No.	DATE	SUBMITTAL / REVISION DESCRIPTION	DB	APP
2	12/18/2023	NDC-0042_ALIGNMENT ADJUSTMENT AT FIREMAN'S LANE	JR	SL
1	09/13/2023	UPDATED PER NYSDEC COMMENTS	BL	SL
0	08/03/2023	ISSUED FOR CONSTRUCTION SUBMISSION	BL	SL

CHAMPLAIN HUDSON POWER EXPRESS
SEGMENT 6 (PACKAGE 4A) - CP: BALLSTON TO GLENVILLE
EROSION AND SEDIMENT CONTROL PLAN
STA. 40368+00 TO STA. 40398+00

Segment 6 (Package 4A)
EM&CP Appendix J
HDD Design Summary Report Additions for HDD 57B

UPDATES TO
HDD Design Summary Report
Crossings HDD 51 to HDD 61
in Segment 6 – Package 4A
For HDD 57B
For Design Rev. #1 || Design Rev. Date: 12/20/2023

Locus Map

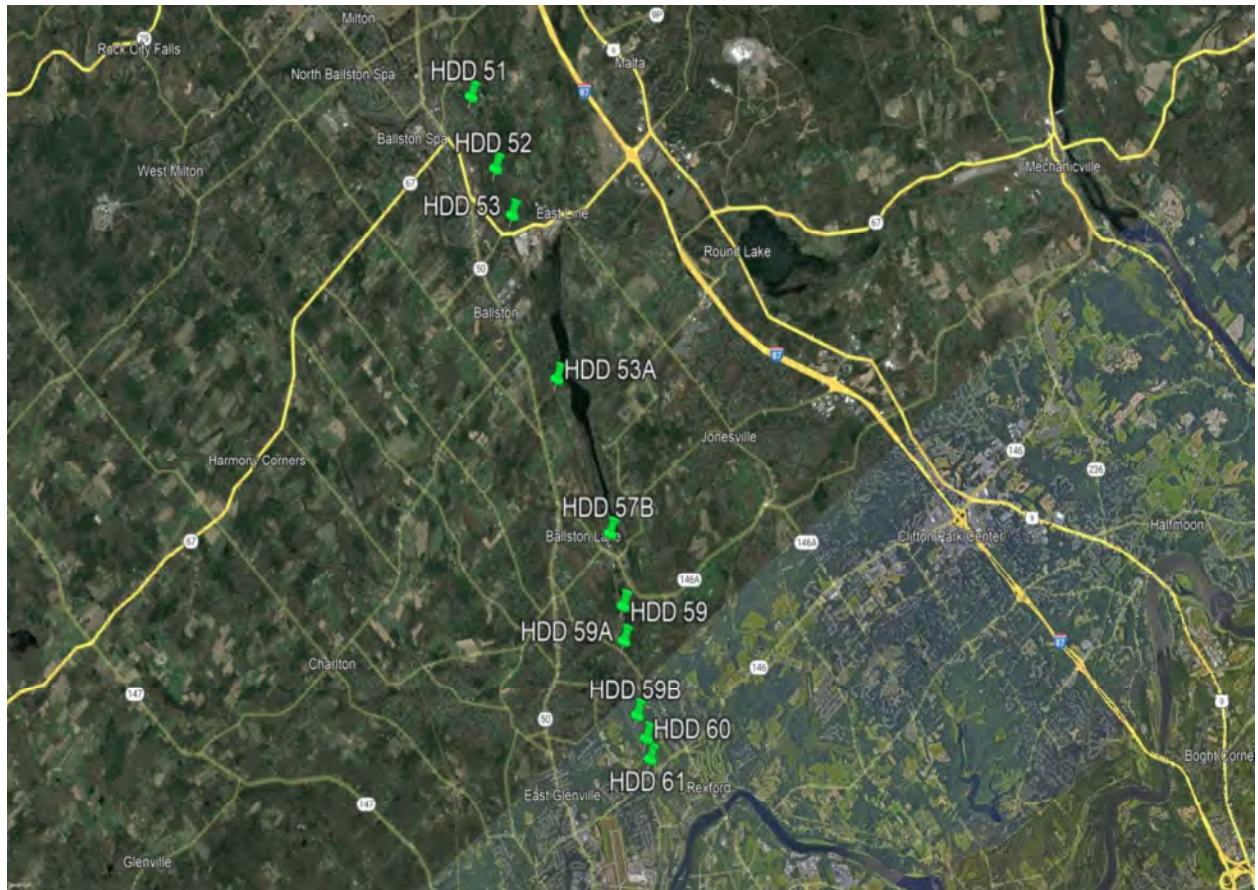
Revised
